**POLARIS**

# TECHNICAL SERVICE BULLETIN

Bulletin Number: L-17-03  
Model Years: 2016-2018

### SUBJECT: 2016-2018 GEM LH STALK SWITCH

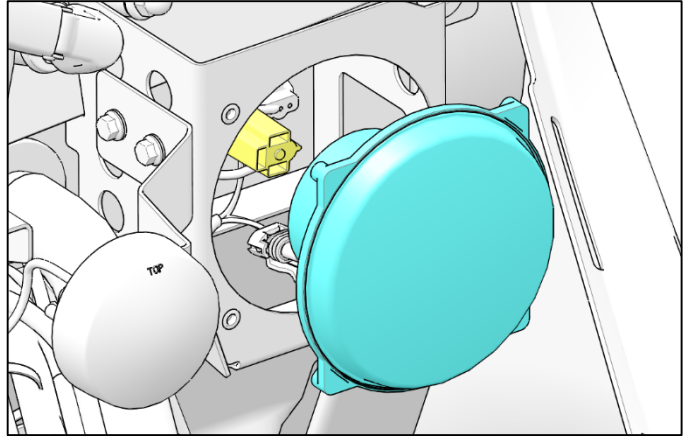
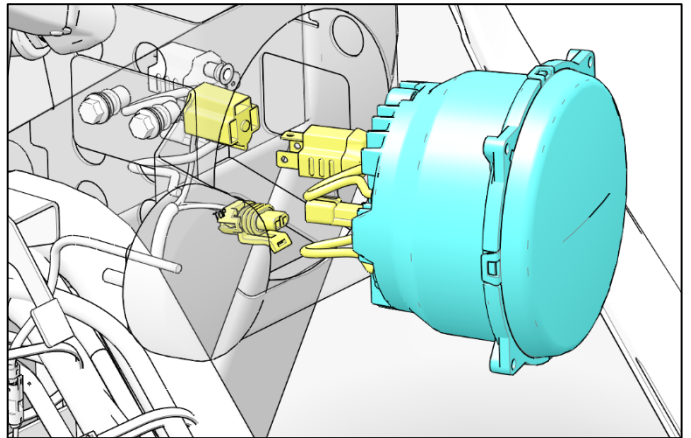
6. Unplug headlight electrical connector. Remove and discard halogen headlight.

7. Install LED headlight ([PN 2413644](#))

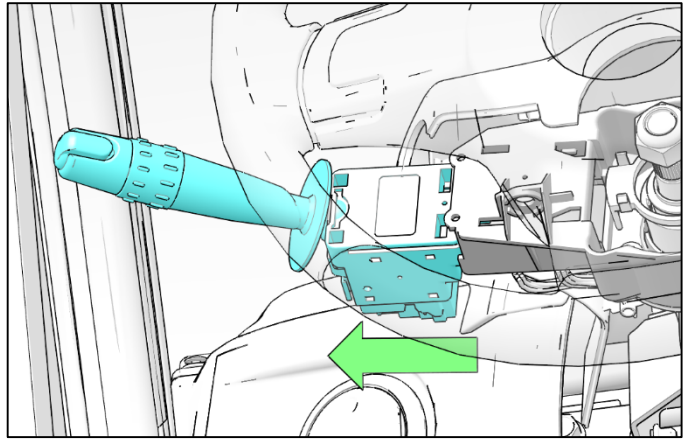
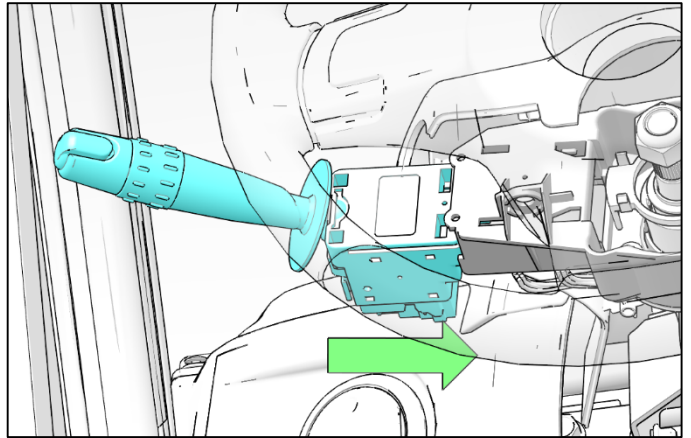
16. Remove and discard LH switch.

17. Install new LH switch (PN 4015403).
